Addendum No. 03

June 9, 2026

Parlier HS Stadium Replacement

PBK PROJECT NO.: 250093
DSA FILE NO.: 10-H12
DSA APPLICATION NO.: 02-124002 _ PARLIER HS STADIUM REPLACEMENT

PARTIAL HORIZONTAL CONTROL PLAN AND TABLE
CS4.3

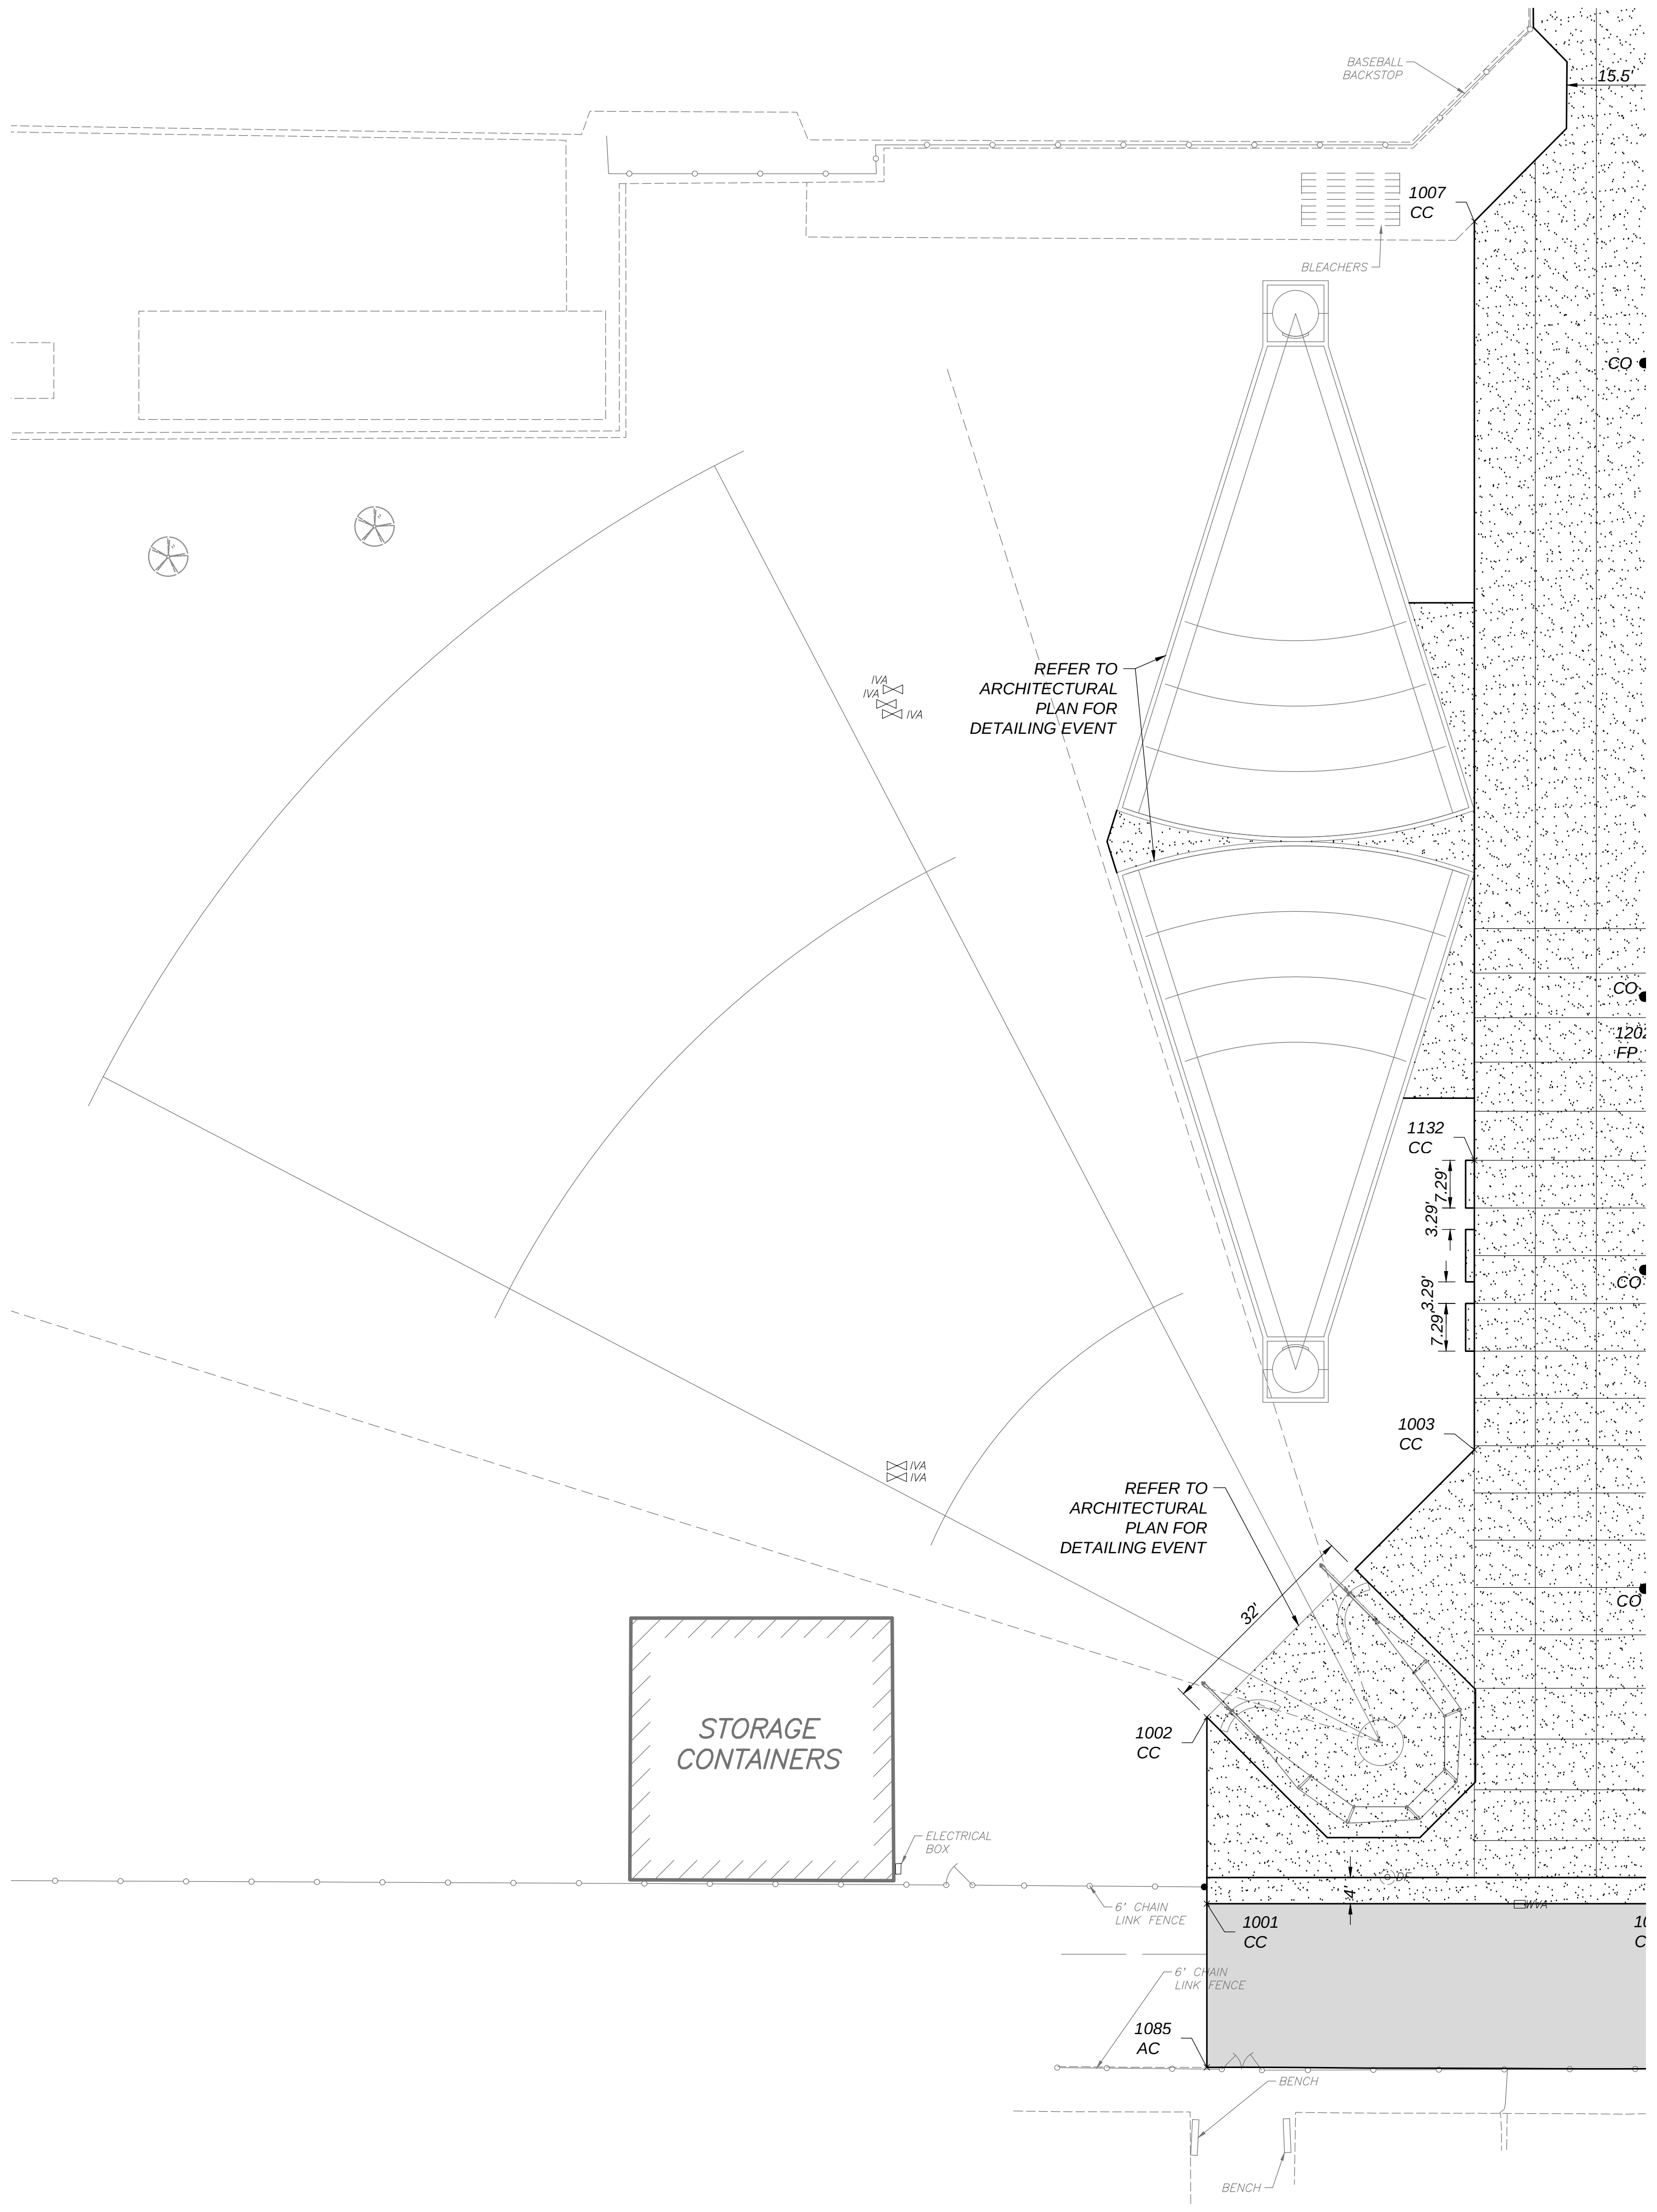
8. Refer to sheet CS4.3 “PARTIAL HORIZONTAL CONTROL PLAN AND TABLE”
    a. Remove and replace sheet CS4.3 “PARTIAL HORIZONTAL CONTROL PLAN AND TABLE” with herein attached sheet CS4.3 “PARTIAL HORIZONTAL CONTROL PLAN AND TABLE” identified with AD3 on the bottom right-hand corner.

- Added horizontal control points and Alternative Deduction 6.

PARTIAL GRADING PLAN
CS5.2

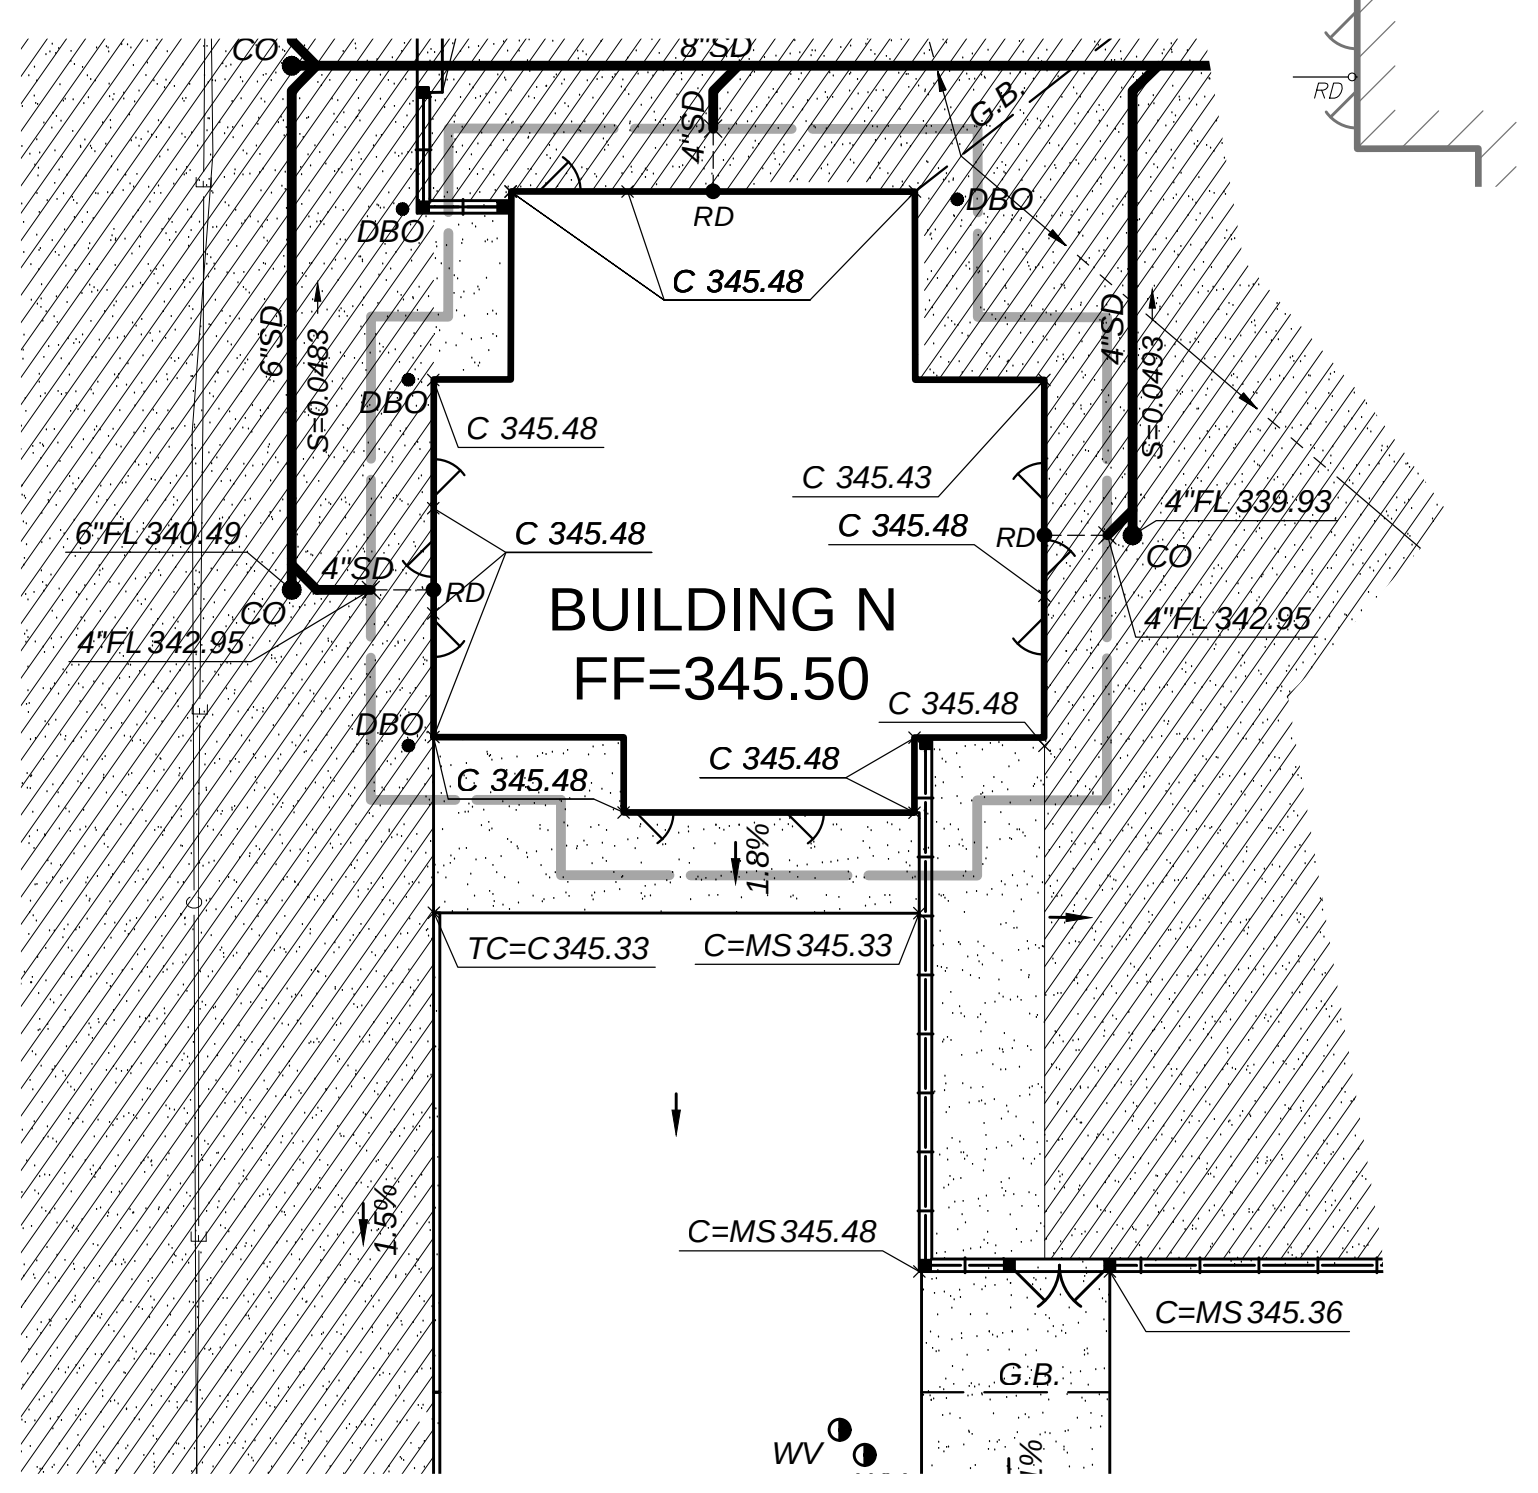
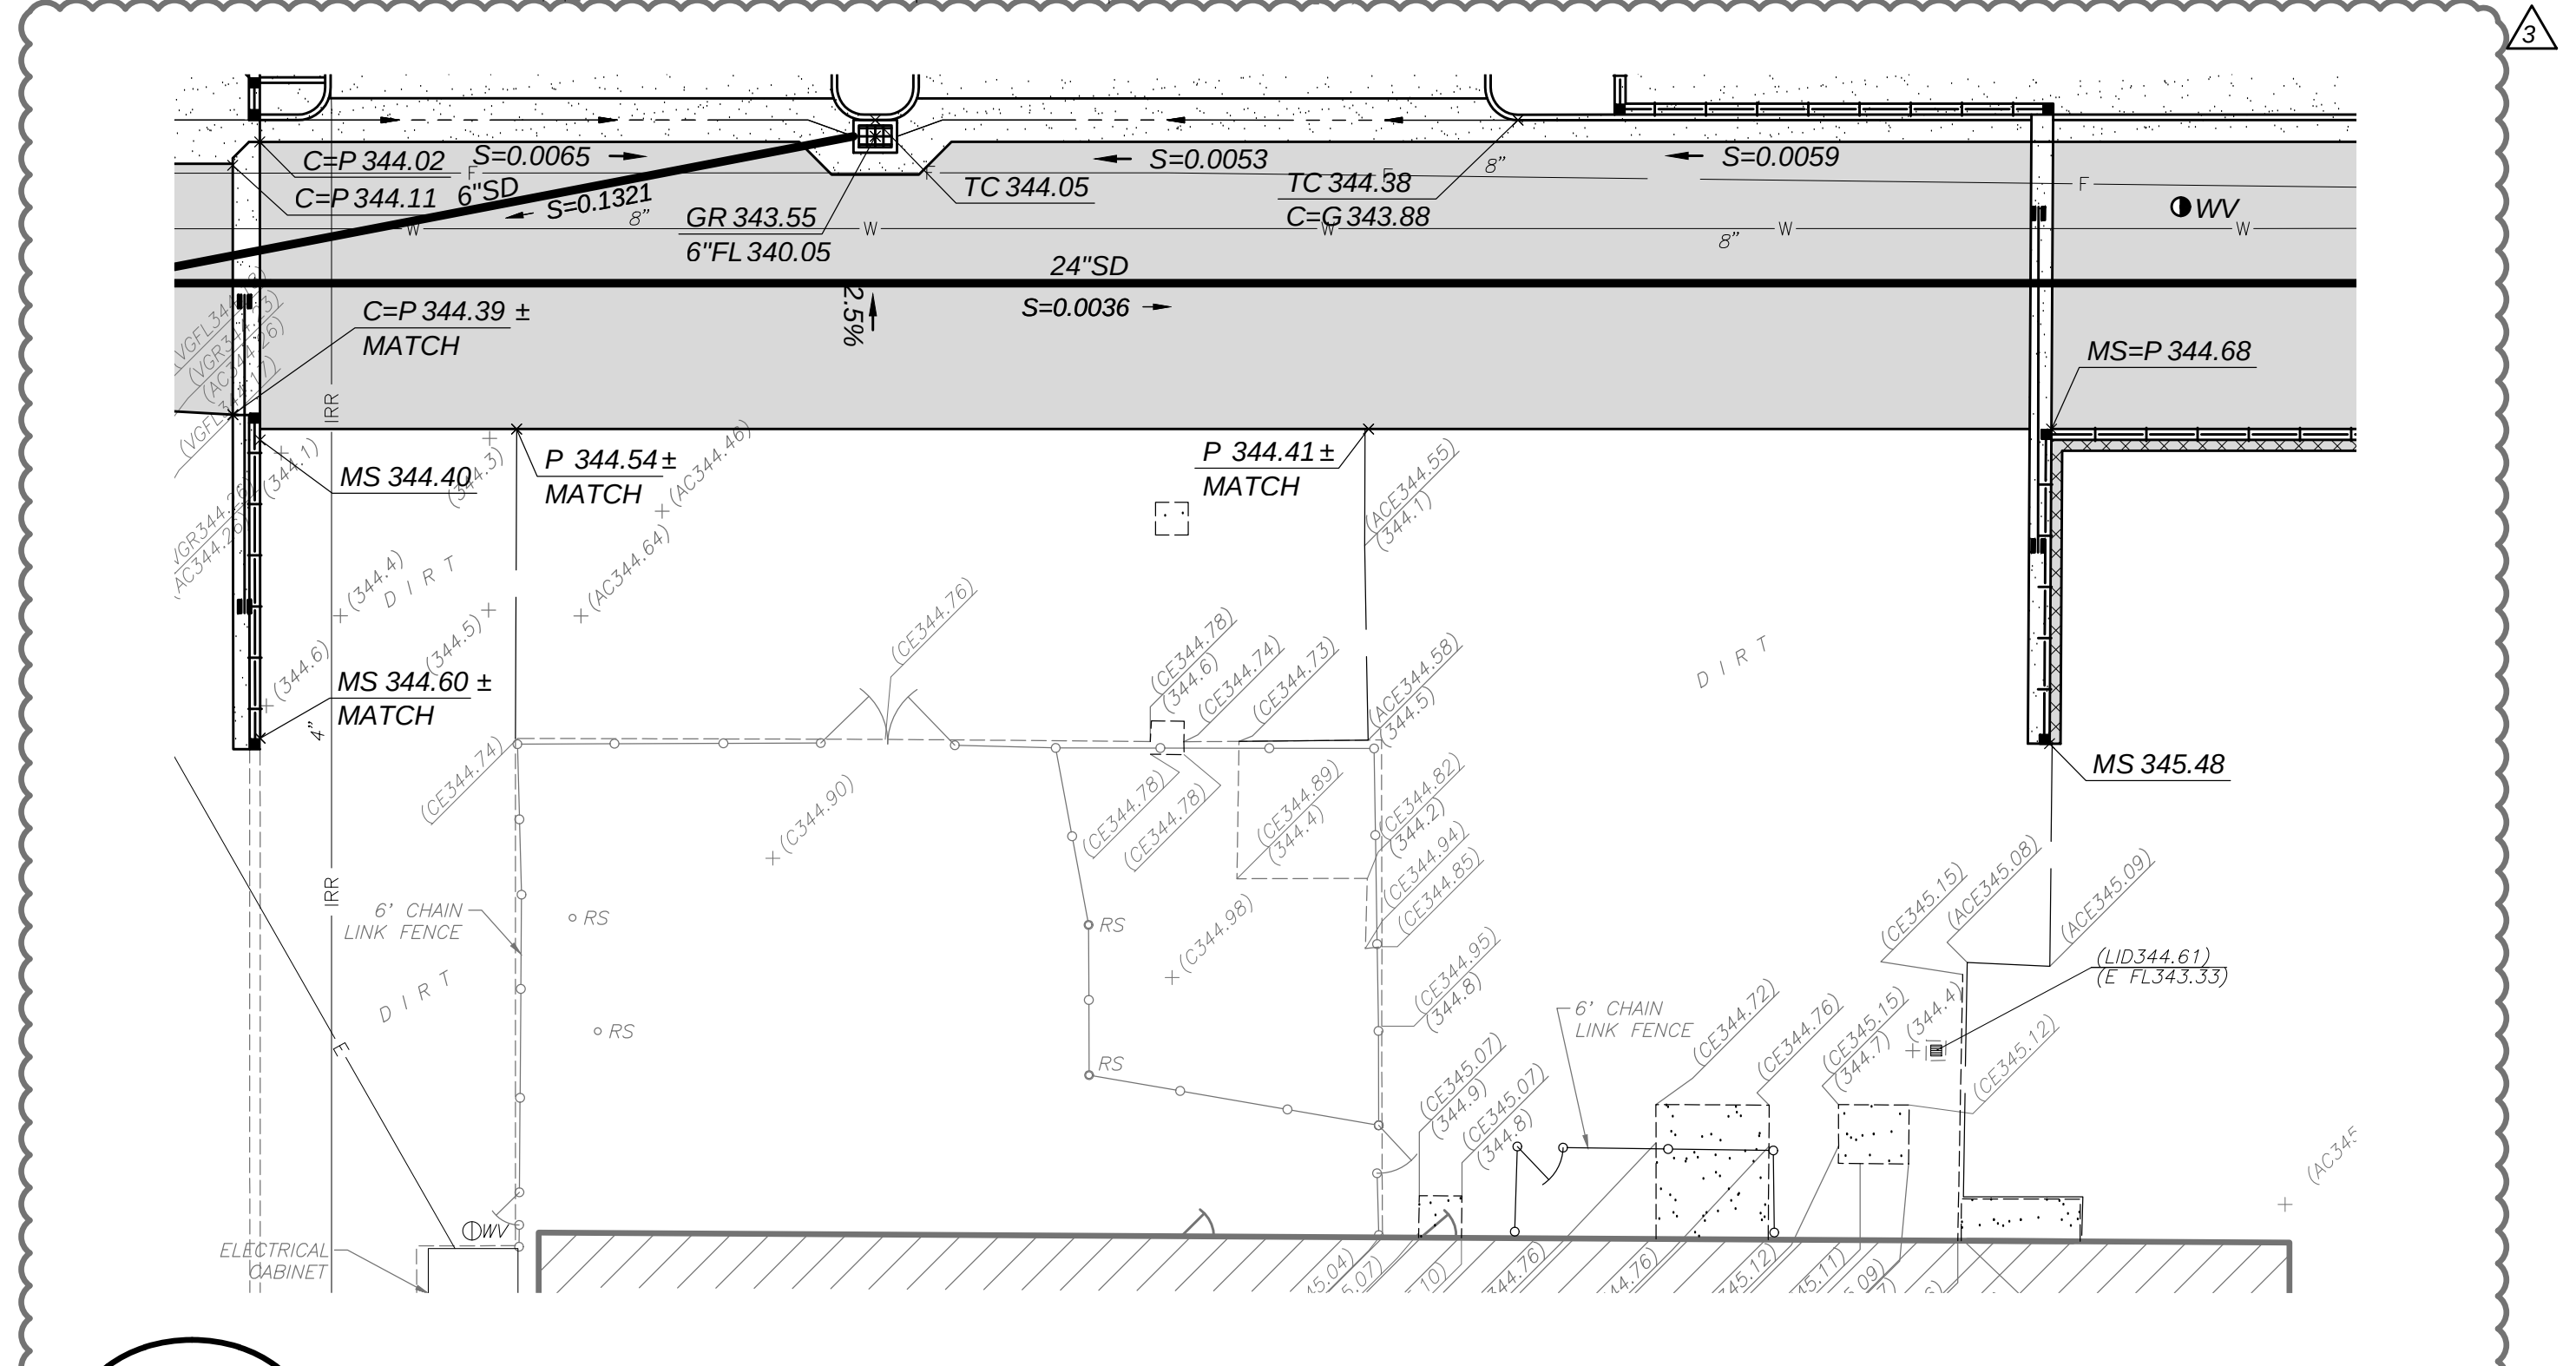
9. Refer to sheet CS5.2 “PARTIAL GRADING PLAN”
    a. Remove and replace sheet CS5.2 “PARTIAL GRADING PLAN” with herein attached sheet CS5.2 “PARTIAL GRADING PLAN” identified with AD3 on the bottom right-hand corner.

- Revised grading per Site Plan revisions and Alternative Deduction 6.
